UNITED STATES  
NUCLEAR REGULATORY COMMISSION  
WASHINGTON, D.C. 20555-0001

SUBJECT: SUPPLEMENTARY INFORMATION SUPPORTING THE U.S.  
NUCLEAR REGULATORY COMMISSION'S REQUEST FOR  
ADDITIONAL INFORMATION TO THE NUCLEAR ENERGY  
INSTITUTE ON HIGH BURNUP FUEL CHARACTERISTICS

### PNNL Review of TR-1001281

Figure 1-1 Application of CSED Approach to Aluminum Alloys (Figure 5-2 of Report)

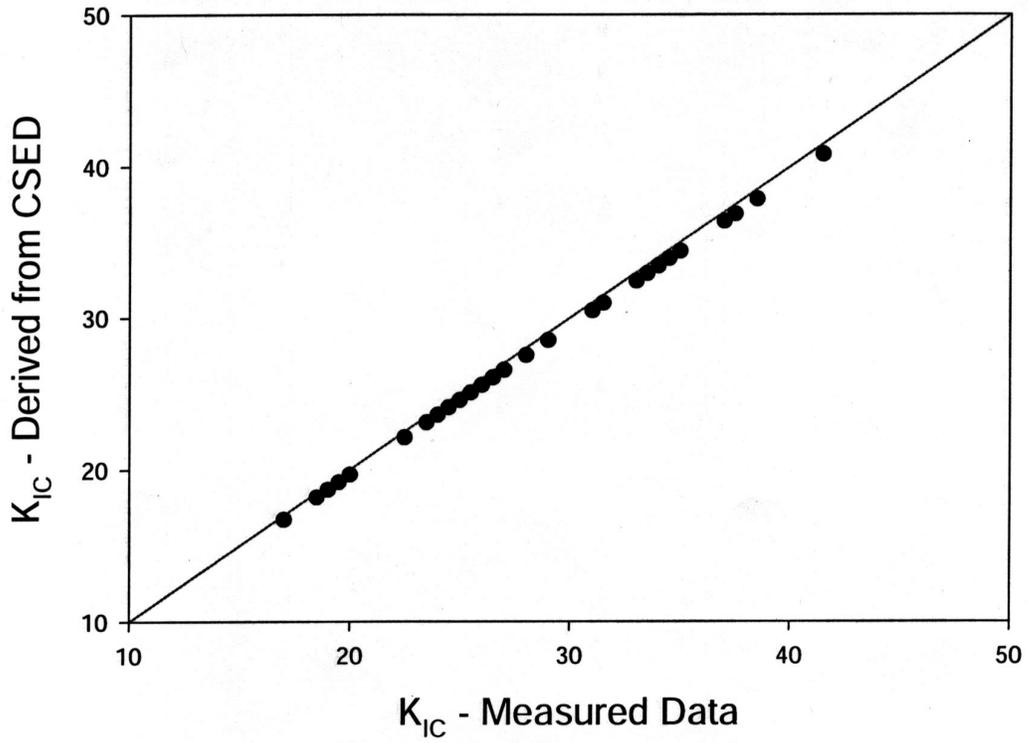
The report presents an example application of the CSED criteria to aluminum alloys as shown by Figure 1-1 (Figure 5-2 of the report). The data on this plot show very good agreement between measured and predicted values for  $K_{IC}$ .

**Figure 1-2 Trial Application of Critical Strain Energy Density Methodology to Data for Ferritic Steels**

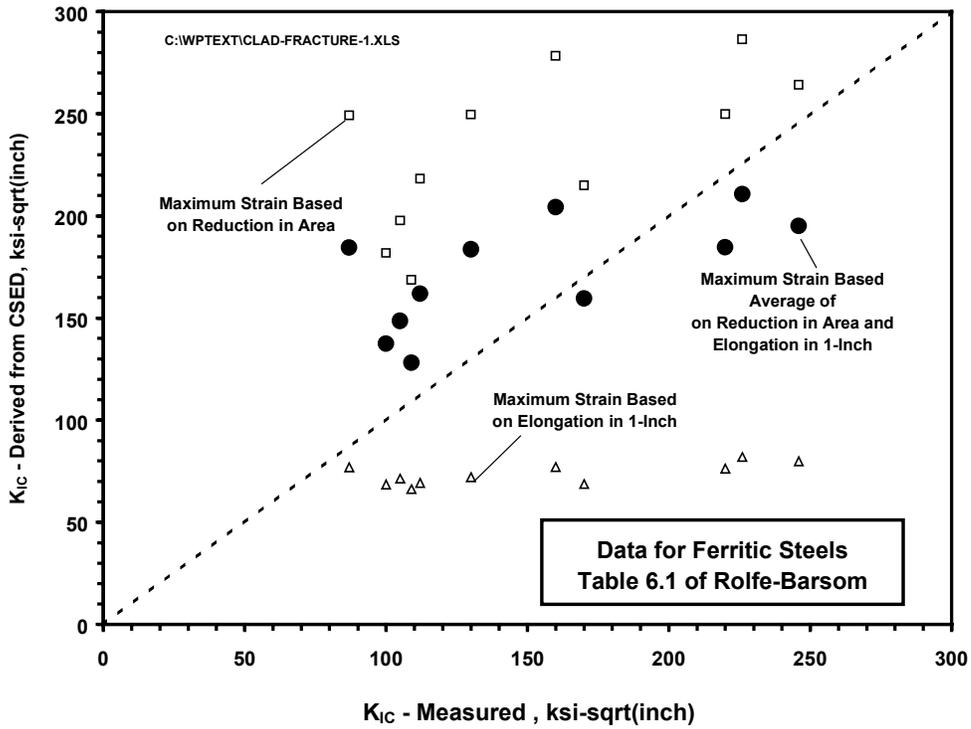
Predicted and measured toughness values for the ferritic steels can differ by a factor of two rather than by ten percent or less as was the case for aluminum alloys. Given the assumptions made in developing the CSED equations, the observed scatter in predicted values is not surprising. The almost total lack of scatter for the aluminum alloy is perhaps more surprising. The apparently good agreement for aluminum could be the result of fine-tuning of the inputs to the model (use of reductions in area versus elongations) or assumptions such as the assigned value for the critical plastic zone size.

The present review indicates that the correlation to be expected for clad materials would likely be more similar to that shown in Figure 1-2 for ferritic steels rather than the remarkably good correlation seen for aluminum alloys. The CSED method could nevertheless be useful if it is properly calibrated using fracture toughness data for clad materials. The uncalibrated predictions for the toughnesses of ferritic steels and fuel clad are accurate within about factor of two, which shows the merits of the CSED approach. Applications of the CSED approach could be analogous to the common use of Charpy impact energies (CVN) to estimate fracture toughness values. The CSED method could allow a relatively simple test to estimate the toughness for specific heats of materials or in the case of cladding to evaluate materials exposed to various levels of irradiation and or hydrogen concentrations.

**Figure 1-3 Values of CSED from EPRI Report 1001207)**

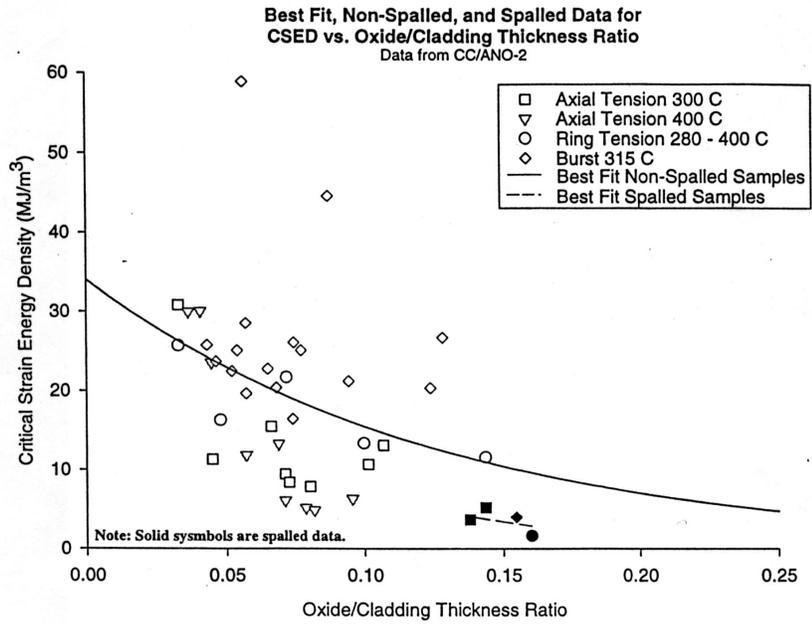
Figure 1-3 is reproduced from page 3-11 of EPRI Report 1001207, and shows CSED values measured from a number of tests of irradiated and hydrided fuel cladding. The extent of the exposure is expressed in terms of the thickness of the oxide layer on the external surface of the clad. The data show a wide scatter in the measured CSED, but with a clear trend of reduced energy levels as the clad experiences high levels of corrosion. PNNL used the CSED data of

**Figure 1-4 Comparison of Fracture Toughness of Clad as Predicted by CSED Approach with Clad Toughness Measured by Fracture Toughness Tests**

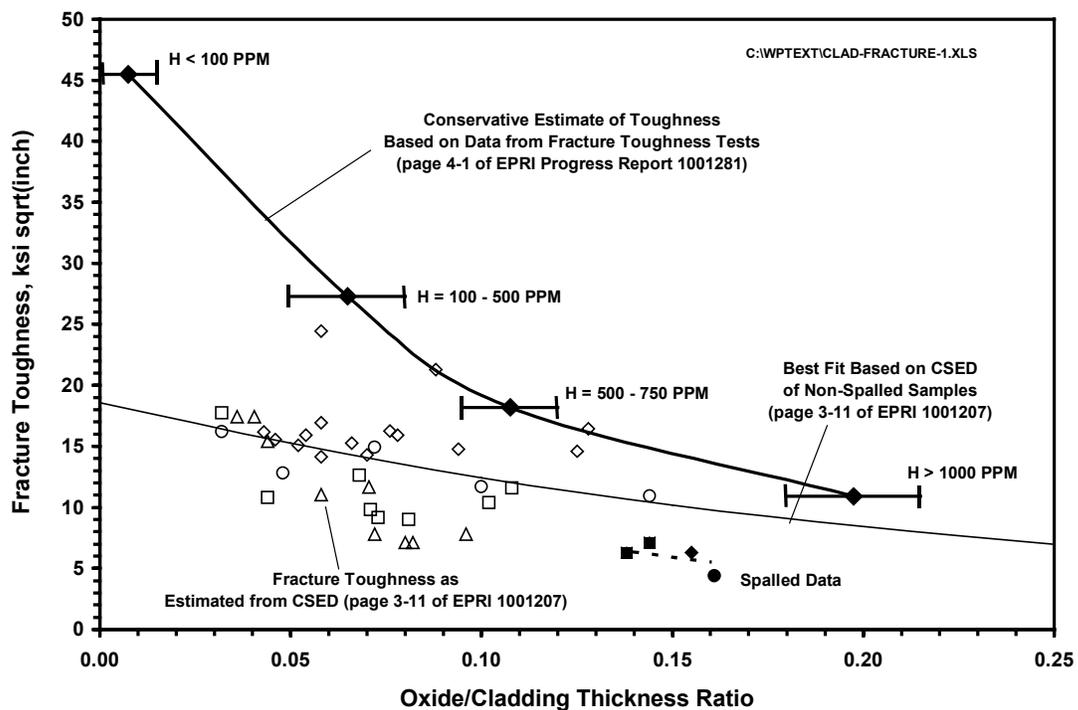
Figure 1-3 and the predictive equations in the EPRI report to predict fracture toughness values. These values are shown by Figure 1-4 along with recommended estimates from the report for fracture toughness as by fracture toughness tests. In order to produce this plot it was necessary to relate hydrogen levels (PPM) to oxide thickness. The solid data points with the indicated hydrogen levels give the assumed correlation. The correlation is subject to large uncertainties and should be updated as better estimates become available. Figure 1-4 does however provide some useful insights. In general, the estimates of fracture toughness from the CSED approach are more conservative than the estimates based on data from fracture mechanics tests, although in a few cases the CSED approach gives higher fracture toughness levels than the conservative curve from the toughness data. This would be expected because the CSED curves are based on tensile and burst tests of high burnup cladding, i.e., with non-uniform hydrides, while the fracture toughness data are from clad with uniformly distributed hydrides (artificially induced). In general, the data show that high burnup cladding with non-uniform hydrides seems to have lower ductility than cladding with uniform hydrides, and materials with lower ductility generally have lower fracture toughness than those with higher ductility. Note that the scatter in CSED estimates is large and similar to the scatter noted in the data from fracture toughness tests. The figure appears to demonstrate that spalled cladding has much lower fracture toughness than non-spalled cladding at equivalent oxidation and hydrogen pickup.

Figure 2-3 Minimum Toughness to Arrest a Running Crack

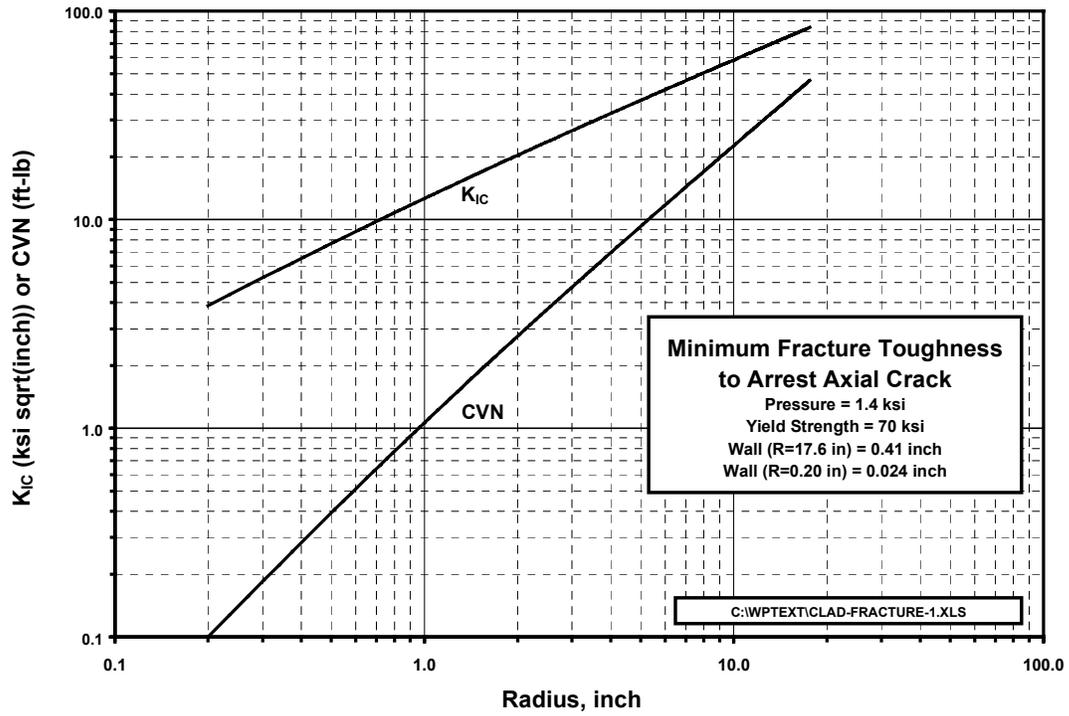
Figure 2-3 shows the result of the calculations in terms of both CVN impact energies and the corresponding values of fracture toughness  $K_{IC}$ . The fracture toughness was correlated to the CVN values by an equation given in Rolfe and Barsom for the temperature transition region ( $K_{IC}^2/E = 5 \text{ CVN}$ ). A very significant size effect is shown by Figure 2-2. Whereas a pipeline with a radius of 17 inch would require a minimum toughness of about 80 ksi√inch to ensure crack arrest, the required toughness is reduced to about only 3 ksi√inch if the pipe size is reduced to the dimensions of a fuel rod. This minimum toughness for crack arrest is less than the minimum toughness of 5 to 10 ksi√inch estimated in the NEI report for irradiated and uniformly hydrided Zircaloy clad. The issue here is that uniformly hydrided Zircaloy (used to establish the minimum fracture toughness) appears to have higher ductility than observed in high burnup cladding that is non-uniformly hydrided (based on tensile and burst tests). Therefore, it can not be precluded that high burnup (non-uniformly) hydrided cladding may have lower fracture toughness values than the 5 - 10 ksi√inch range observed for uniformly hydrided Zircaloy.

**Figure 3-1 Clad with Through-Wall Crack at Blister**

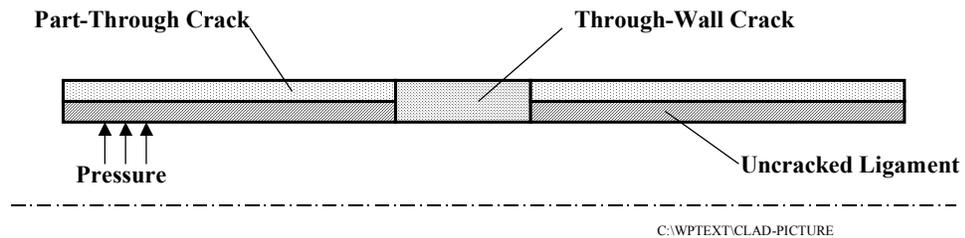
A second failure mode addressed by PNNL is related to blisters (a region of spalled oxide layer). It was assumed that the spalled oxide would locally remove the insulating oxide layer and this would result in a cold spot. If hydrogen concentrates in such a cold spot, hydrogen platelets could form through the entire wall thickness. Accordingly, the fracture mechanics calculations considered an axial through-wall crack extending across the full diameter of the spalled region as indicated in Figure 3-1. The calculations evaluated the stability of this through-wall crack, and the potential for a large breach in the clad.

These stress intensity factors (even for the smallest crack) could exceed the fracture toughness of the relatively tough material of the clad inside of the hydride rim. Therefore, there is a potential for unstable growth of axial cracks if: 1) the blister diameter becomes sufficiently large, and 2) the full wall thickness becomes severely hydrided over this region. The calculations also assumed that a long axial crack forms within the blister, and that this crack penetrates the clad with no opportunity for a slow leak to relieve the internal gas pressure. Actual fuel rod behavior may be such that through-wall cracks could result in a slow leak rather than a long break. However, the simple calculations in Section 2.0 show that crack propagation is possible and that further analysis is needed. The final length of the axial fracture will depend on how rapidly the gas pressure is released compared to the velocity of crack propagation.
